**From:** [Nicholas Davies](mailto:nbdavies@gmail.com)  
**To:** [Zoning](#)  
**Cc:** [falch.ryan@msnairport.com](mailto:falch.ryan@msnairport.com); [jeff.manzetti@meadhunt.com](mailto:jeff.manzetti@meadhunt.com)  
**Subject:** Reject airport appeal & add path connection (93069)  
**Date:** Sunday, May 17, 2026 11:24:59 AM

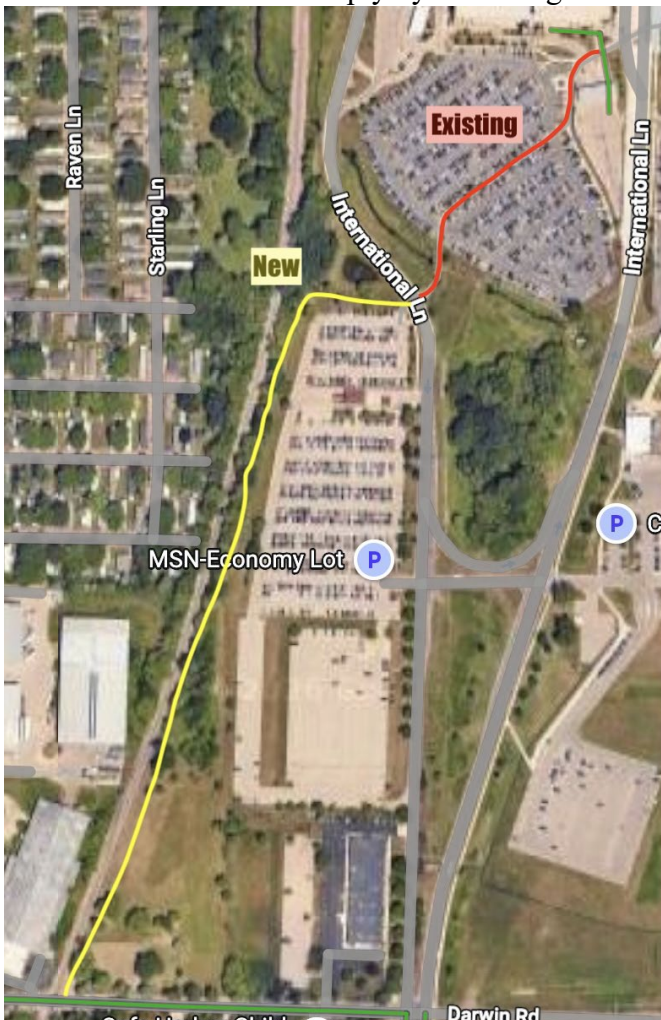
With the parking connecting all the way through to Darwin Rd, this represents another entrance/egress to the airport property for cars, without adding connectivity for other modes. This could be rectified simply by extending the existing segment of multi-use path as shown:

This would have only a marginal impact on the overall airport parking capacity, which would

still be net-increasing (which is contrary to Dane County's climate goals of reducing overall VMT).

While the project will address a sidewalk network gap on Darwin Rd, there will still be a sidewalk gap to the east, to reach the Darwin & International intersection. That's partly why it's so important to provide a pedestrian route through this parcel as well.
